Application for Works Approval

Works Approval Number	W6816/2023/1
Applicant	Mt Weld Mining Pty Limited
ACN	053 160 400
File number	DER2023/000295
Premises	Mt Weld Rare Earths Project Elora Road LAVERTON WA 6440 Legal description - Mining leases M38/58, M38/59, M38/326, M38/327, G38/34 and G38/35 As defined by the map in Schedule 1 of the Works Approval
Date of report	22 February 2024
Decision	Works approval granted

Figure 1: Plan showing the potential flow of lateral seepage during commissioning.

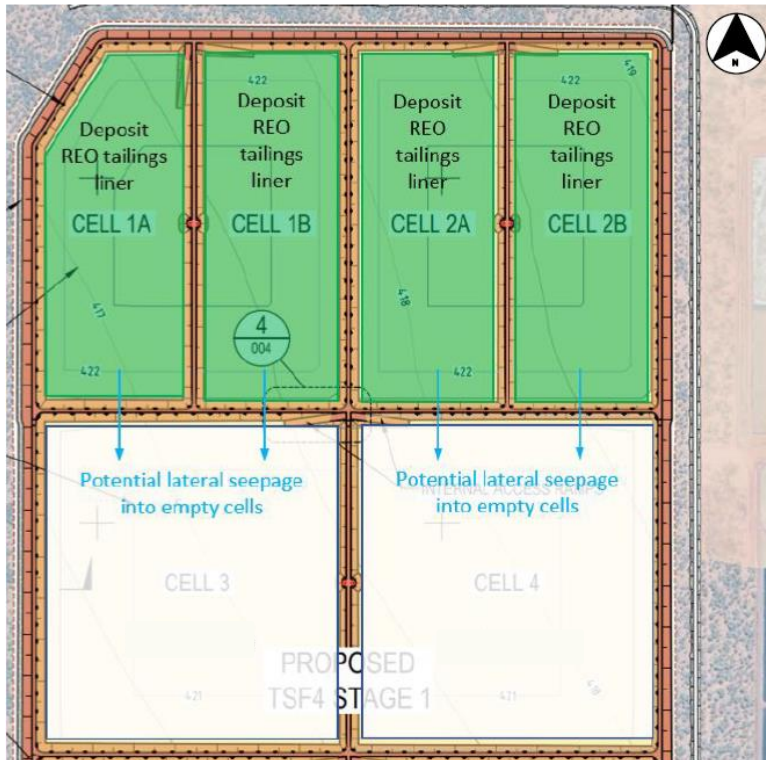
<p>Decision Report (Section</p>	<p>The Applicant requested that the condition be modified to allow deposition of REO tailings into Cells 3 and 4 to establish the 1m low permeability</p>	<p>Similar to above, the Delegated Officer notes that deposition into Cells 3 and 4 is limited to the amount required to develop</p>

Section / Condition Reference	Summary of applicant's comment	Department's response
2.3.1, 3.3 and 5) Works Approval (Condition 11)	layer. To minimise the risk of lateral seepage outside of the TSF footprint, the Applicant proposes to extend the perimeter embankments of Cells 3 and 4 by installing a 1m high bund. The Applicant expects that any seepage that occurs will be contained within Cells 5 and 6, evaporate or will be pumped off using on-site pumps.	<p>the required low permeability foundation layer. The Applicant has proposed additional controls for managing lateral seepage associated with tails deposition into Cells 3 and 4 in the form of a 1m high earthen bund positioned along the perimeter of the future Cells 5 and 6. Recognising that drainage flow is generally to the southwest, the western bund wall will be extended to prevent surface seepage flow beyond the footprint of the TSF.</p> <p>Noting that deposition will be short term (up to 4 months) prior to final consolidation of the 1m low permeability later, the Delegated Officer considers that lateral seepage through the Cell 3 and 4 internal embankments will be limited.</p> <p>Considering the short-term duration of seepage, and Applicant controls in place to mitigate lateral seepage beyond the TSF footprint, the Delegated Officer has determined that temporary deposition of tailings into Cells 3 and 4 will not alter the risk profile of the premises and has amended the conditions accordingly. Deposition will be allowed subject conditions specifying the stages of construction of the TSF cells to ensure that bund walls for preventing seepage flow outside of the TSF footprint are installed.</p>

Figure 2: Typical section of evaporation pond perimeter embankment

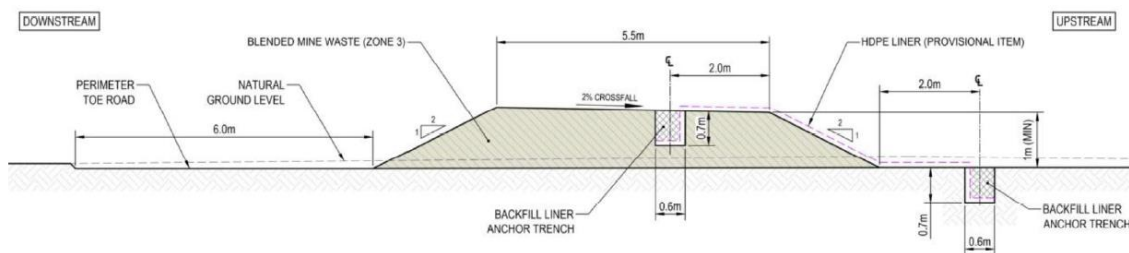
Decision Report (Section 2.3.2 and 3.3) Works Approval (Conditions 6, 7 and 9)	The Applicant noted that the HDPE lined proposed on the perimeter embankments of the Evaporation Pond is a provisional item and that during construction of the Evaporation Ponds, the geotechnical engineer may determine that the HDPE liner is not essential for managing stability of the embankments. The removal of the HDPE is considered by the Applicant not to change the environmental risk or outcomes of the design noting that the liners relates to the geotechnical stability of the embankments rather than preventing seepage impacts to groundwater.	Noted. The Delegated Officer accepts that the HDPE liner is a provisional item associated with the management of embankment stability and does not alter risk associated with seepage from the Evaporation Ponds. On this basis, and considering that risks associated with stability are appropriately regulated via the Mining Proposal under the <i>Mining Act 1978</i> , the delegated officer has determined to remove this requirement from the works approval.
